O-360-A4G
NN9757L

Engine Inspection
Camshaft Change

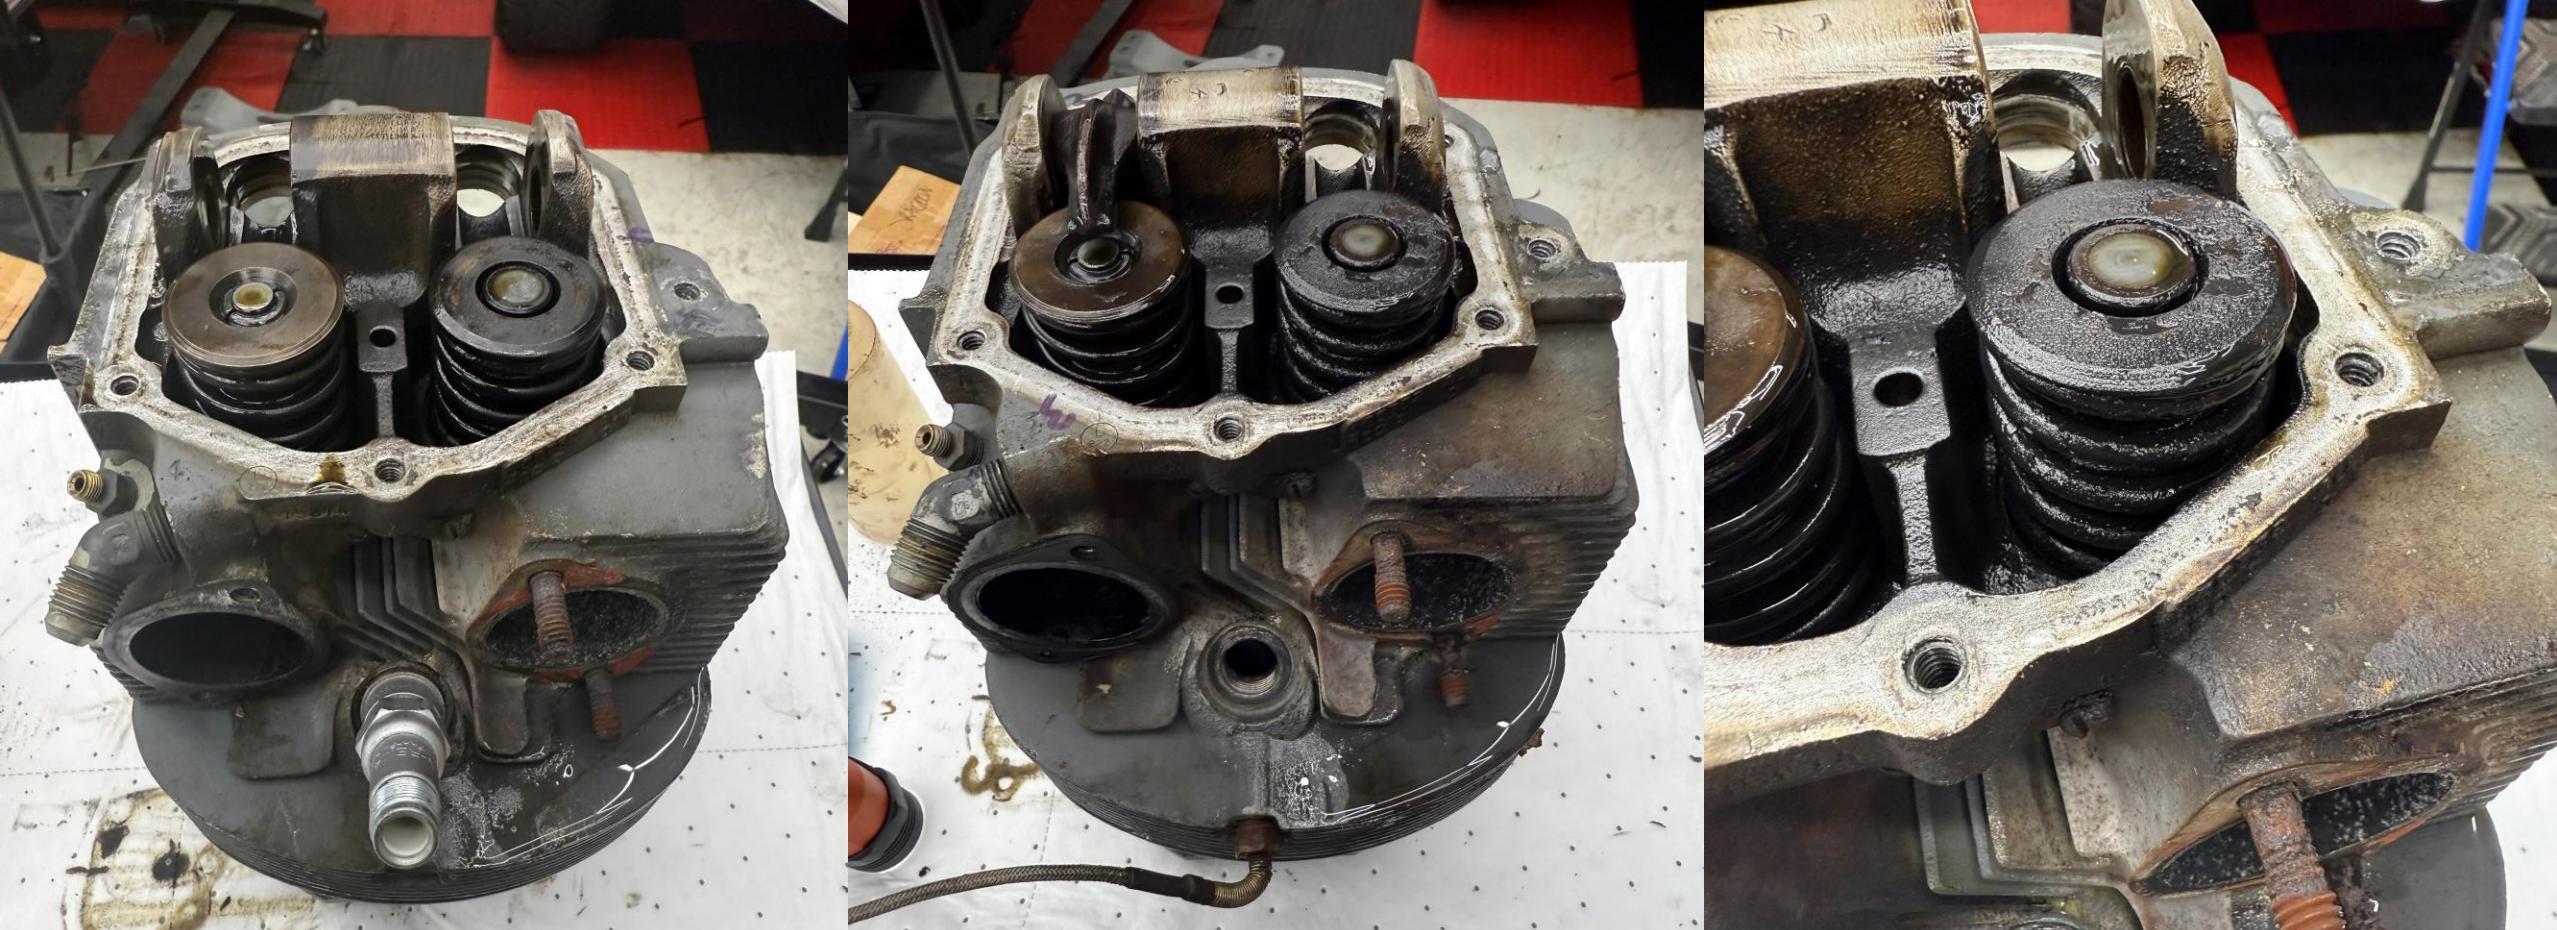
Crankshaft Gear
Rejected due to
not compliant
with Lycoming
MSB475
